In the matter of an application by Cromwell Certified Concrete to replace Discharge Permit - RM16.108.02 (ORC), Water Permit RM16.108.01 (ORC) and Land use consent - RC150052 (CODC) and seek resource consent for the discharge of contaminants to air to authorise the operation and expansion of the Amisfield Quarry

Statement of Evidence of Peter Stacey

For the Hayden Little Family Trust, Nicola and Bryson Clark, and Amisfield Orchard Limited

8th December 2021

Figure 1: Wet days calculated using Cromwell EWS data

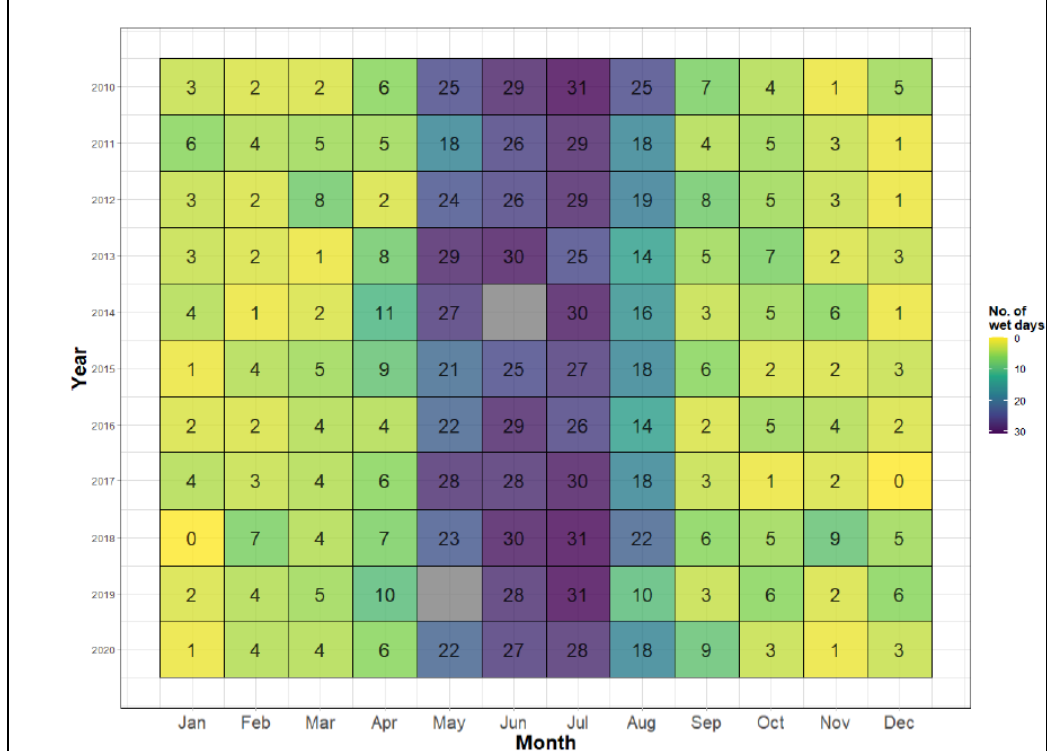
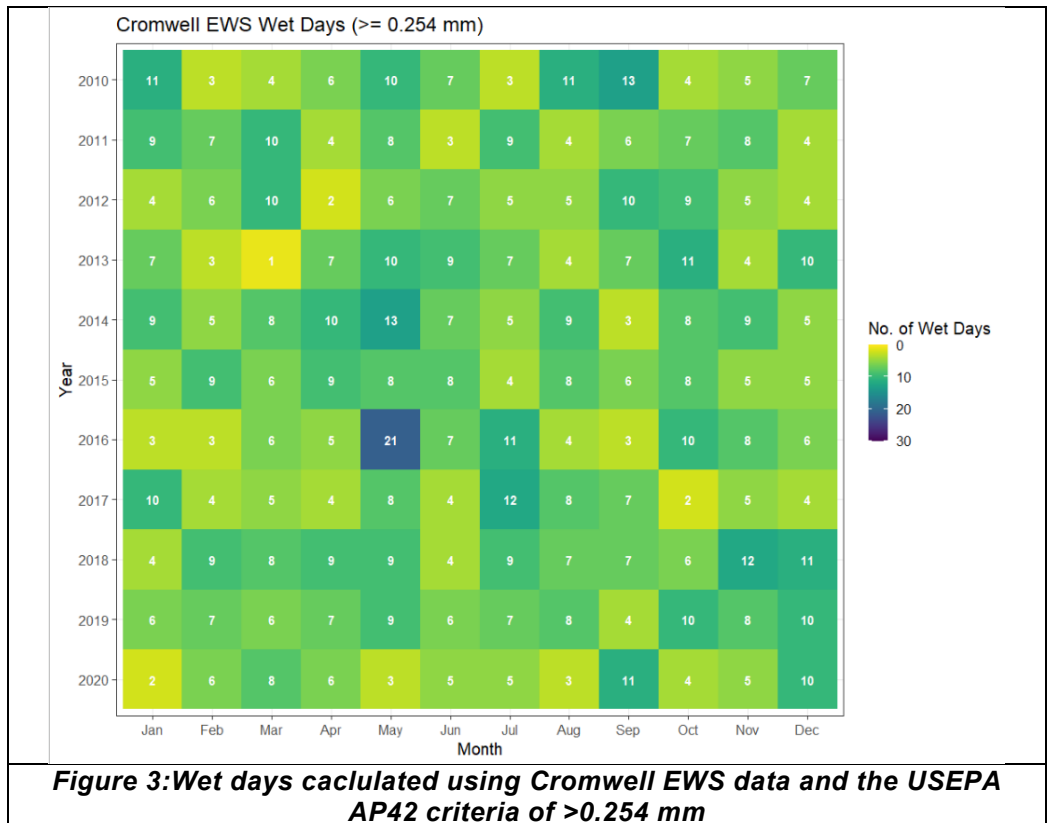
- 60 As part of my review, I have reproduced Figure 2 included in attachment E of Mr Cudmore's evidence (Total number of 'wet days' per month over 11 years as a tile plot), using the Cromwell EWS data that I downloaded from the National Institute of Water and Atmospheric Research (NIWA) CliFlo database. This is attached to my Evidence in **Appendix E, Figure 1** and I have included Mr Cudmore Figure below my figure for comparison purposes in **Figure 2**.

- 61 Based on even a cursory view of the information, there is little similarity between the two Figures, particularly for the number of 'wet days' during winter months. This is due to the difference in the method used to calculate 'wet days', whereby as evaporation rates observed during the winter months are low, Mr Cudmore's method essentially considers all winter days as 'wet days'.

- 68 As shown in Table 2 and **Appendix E, Figure 1**, the average number of ‘wet days’, as per my definition is between 5 and 7 for winter months, notwithstanding any days where the rainfall could be between 0 and 1 mm, I am surprised to see that there are a very small number of dry windy periods during winter months blowing in the direction of any of the receptors identifies in in Attachment G of Mr Cudmore’s evidence.
